MSC APOLLO 13 INVESTIGATION TEAM

FINAL REPORT

PANEL 5C

CORRECTIVE ACTION STUDY
AND IMPLEMENTATION

FIGURE A6

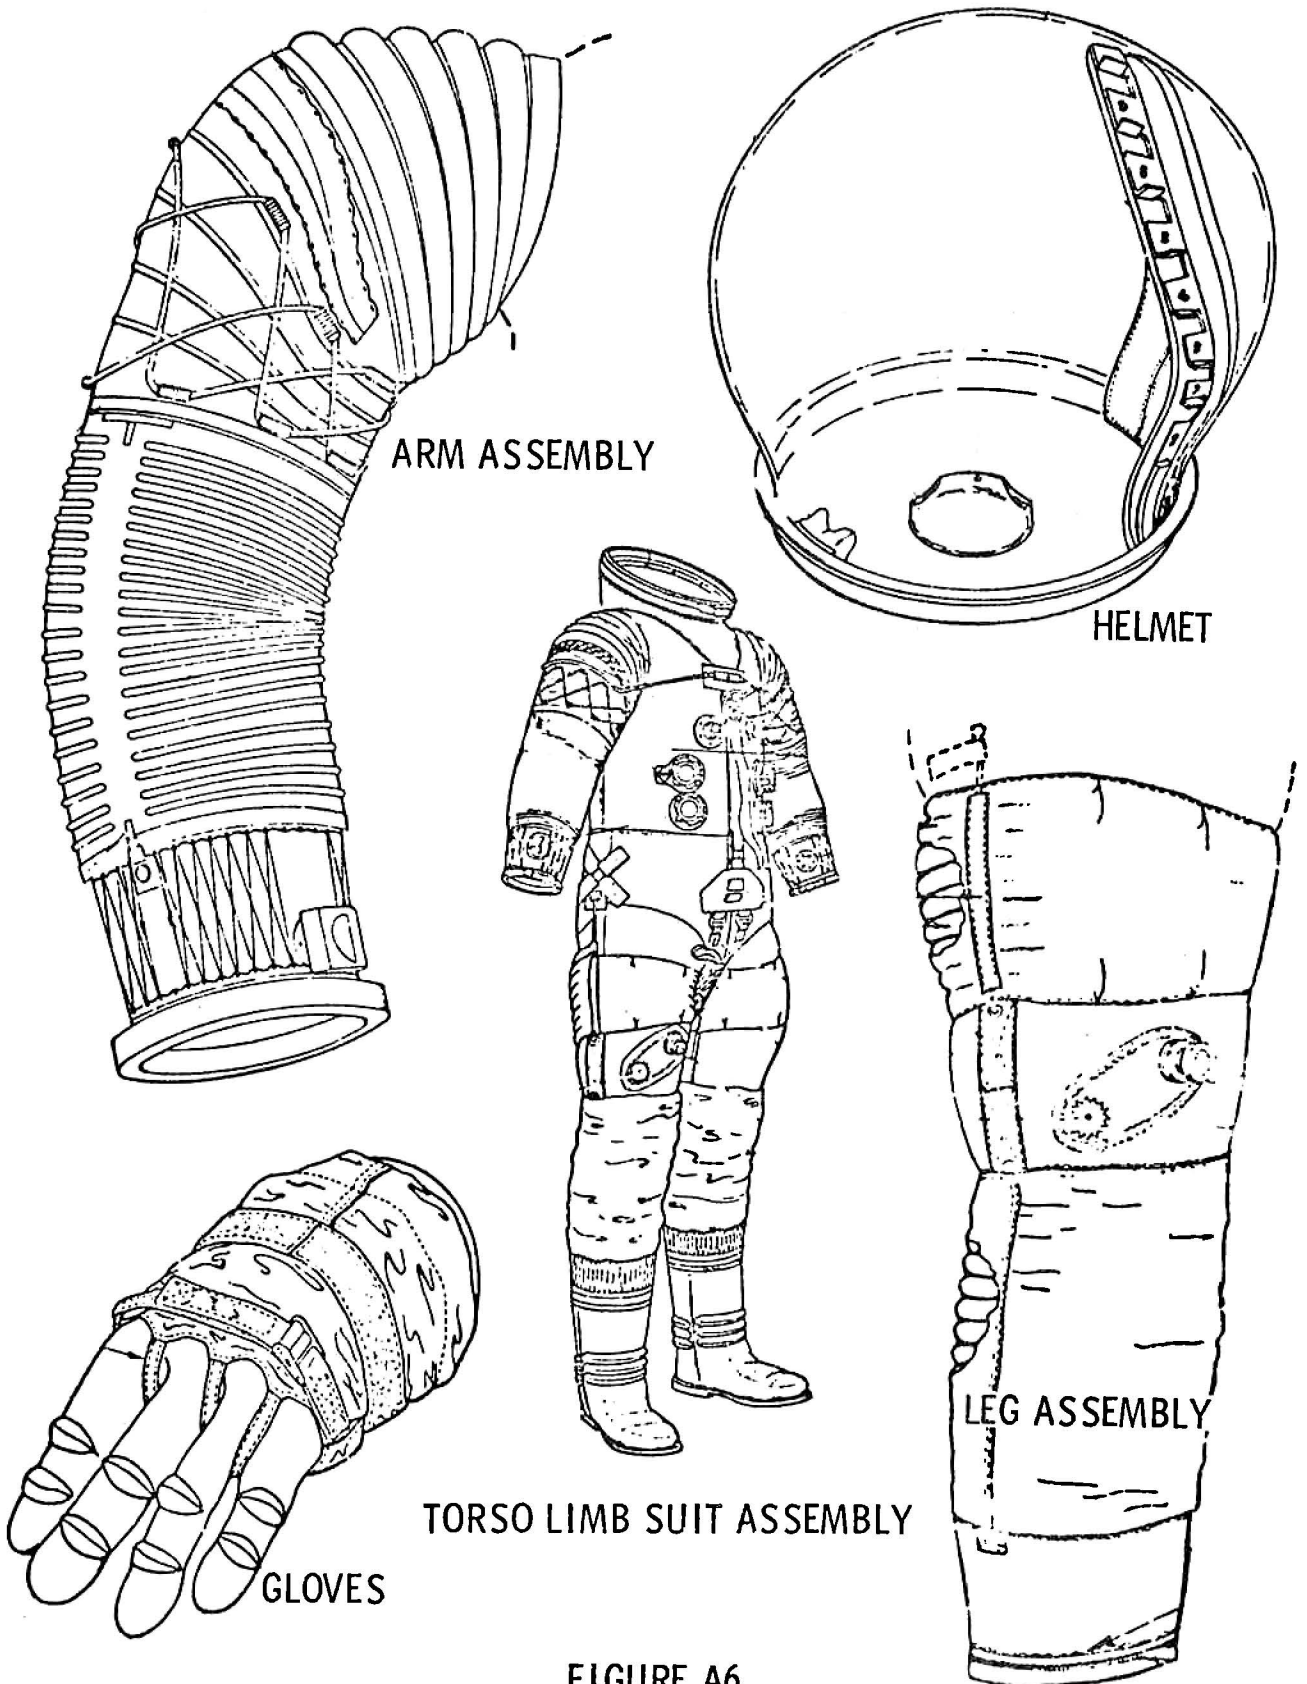
- WHY SPF PRESENT: a. Connectors and other penetrations except for zipper appear to have extremely high reliability with safety lock/locks with no additional modifications required.
- b. Redundant pressure layer could be developed to improve reliability. This concept was investigated early in the Apollo suit development program and was found undesirable. Prototype evaluation indicated that the double wall adversely affected mobility, bulk, and crewman comfort.

- 6E132
- 6E142 Add reinforcement patches
- 7E114
- 6E160 Add protective layer to PGA

- 7E133 Add abrasion cover to IV gloves
- 7E134 Redesign PGA helmet neck ring compression band
- 7E135 Redesign helmet vent pad edges
- 7E175 Add scuff patches to torso limb suit assembly
- 7E335 Modify neck band
- 8E172 Change adhesive on shoulder ring
- 8E300 Add fluorel coating to IV gloves
- 05052 Add redesigned scuff patches and knee patches
- 8E036 Add reinforcement scuff material
- 8E048 Relocate compression band channel slit.
- 8E111 Redesign cable ending
- 8E333 Heat treat compression band bracket
- 9E215 Add scuff layer protection
- 9E386 Incorporate redesigned boot bladder

RECOMMENDATION: No change required.

FIGURE A7

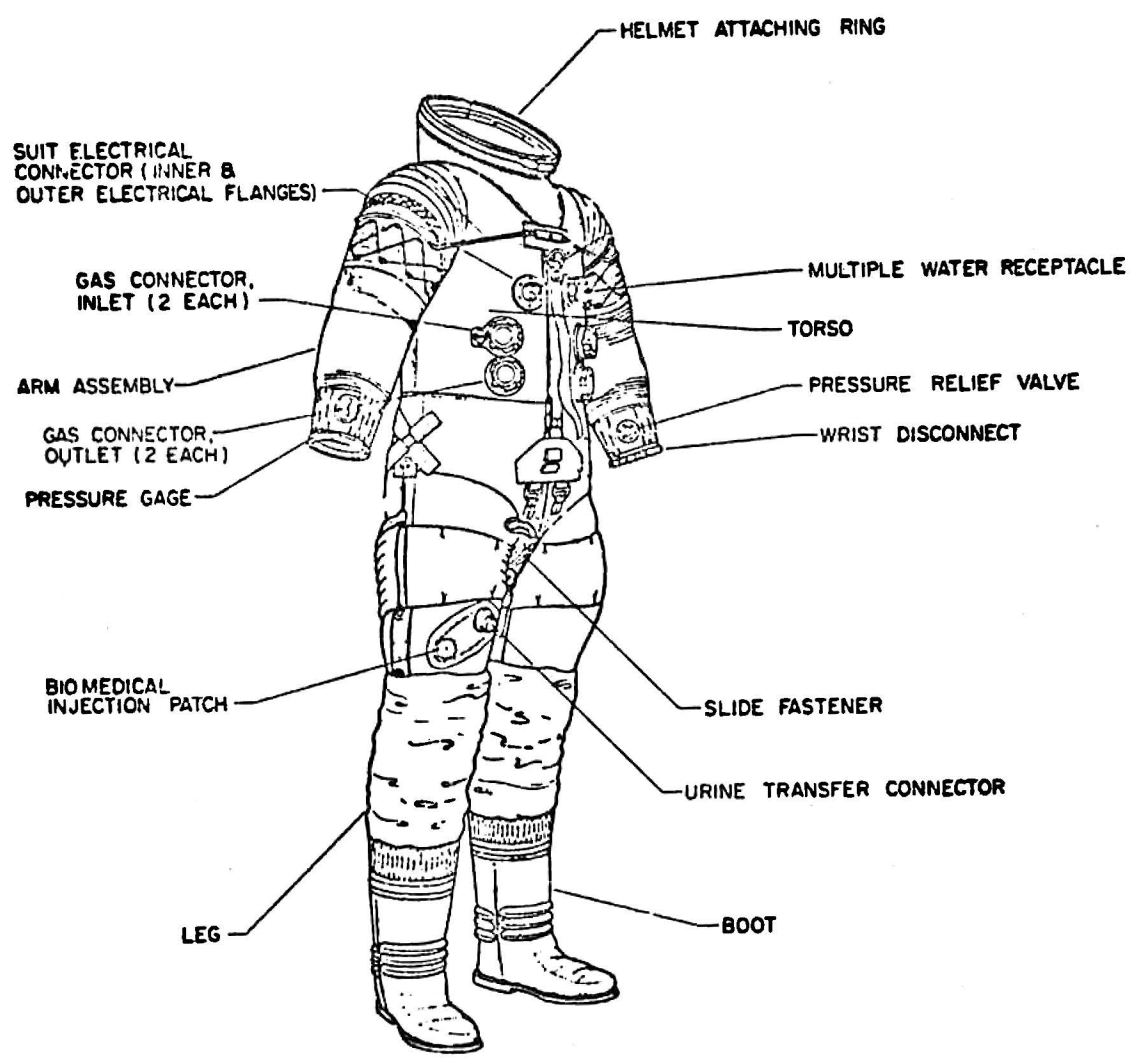
B. Catastrophic failure of a PGA pressure retention layer penetration (i.e. zipper, wrist disconnects, connectors etc.)

- 6E003 Mod. gas connector to stop leak
- 6E097 Change "O" ring from single to double bar
- 6E118 Add lock lock to glove and helmet closure
- 6E179
- 6E142 Modify slide fastener
- 7E076 Add safety locks to gas connectors
- 7E137 Change feedport material to aluminum
- 7E138 Redesign helmet neck ring
- 7E216
- 7E208 Add molded lip seal in wrist disconnect
- 8E035
- 8E034 Redesign wrist disconnect
- 8E108
- 8E109 Change pressure sealing zipper lock lock
- 8E332 Add thick contoured feed port gaskets
- 8E346
- 8E335 Improve operations of slide fastener
- OE025 Change to zipper lock lock
- 8E029 Add lock assembly to neck ring
- 8E268 Redesign helmet slide and suit side neck rings
- 8E362 Change lock tab
- 8E439 Redesign feedport door
- 9E137 Feed port configuration change
